**Technical Service Bulletin:** TSB180025

**Damaged Coolant Thermostat Identified by Fault Codes: 146, 151, 1962, 2646, and 2963**

Figure 1, Coolant Thermostat with Scuffing and Cracks.

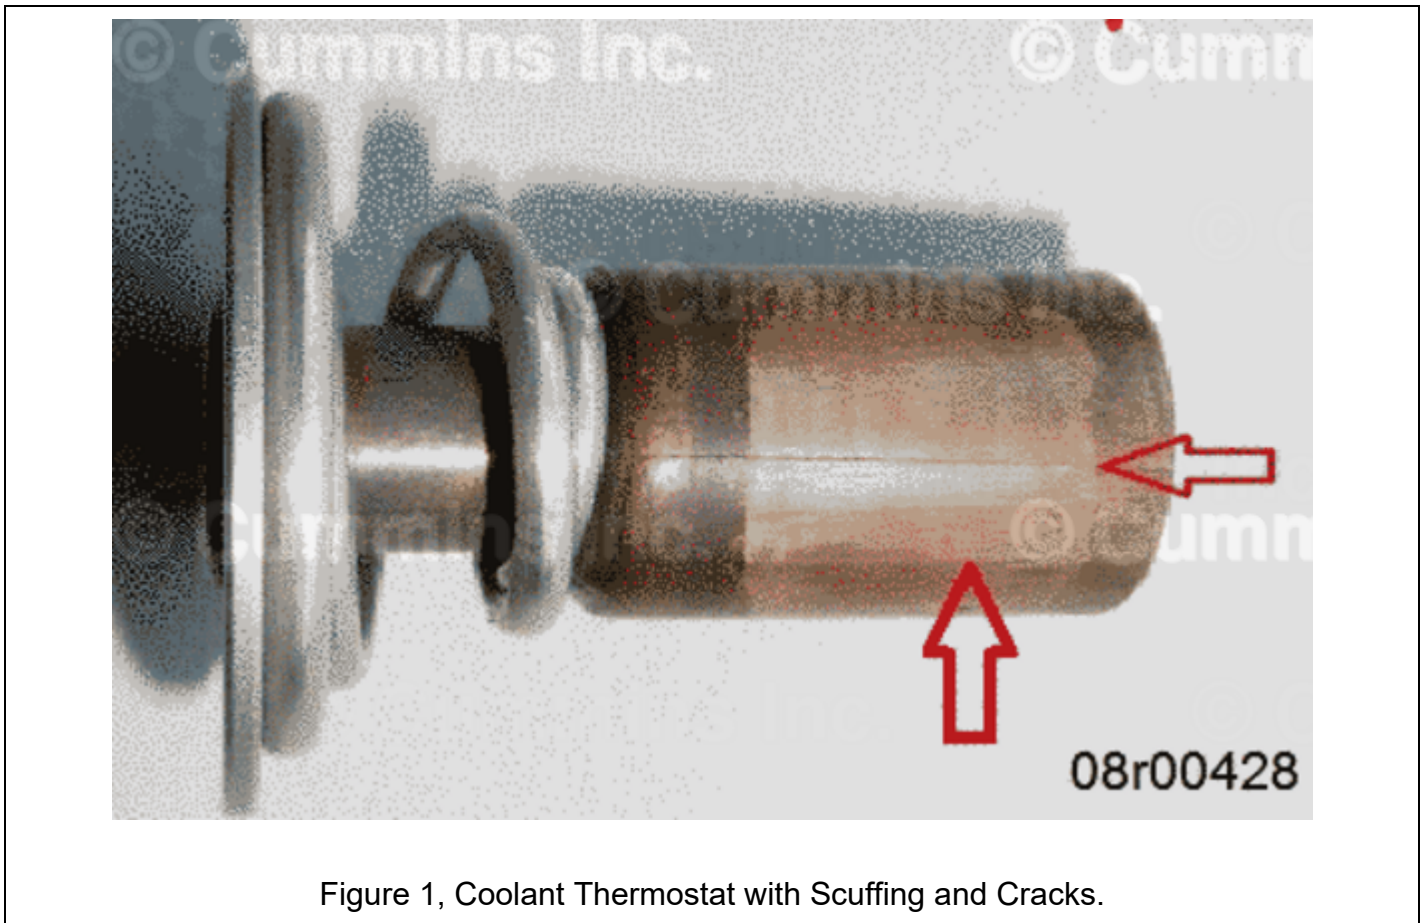
Inspect coolant thermostat for damage. See Figure 1.

Replace coolant thermostat with the new part number in Table 1 below. Reference Procedure 008-013 in the corresponding Service Manual.
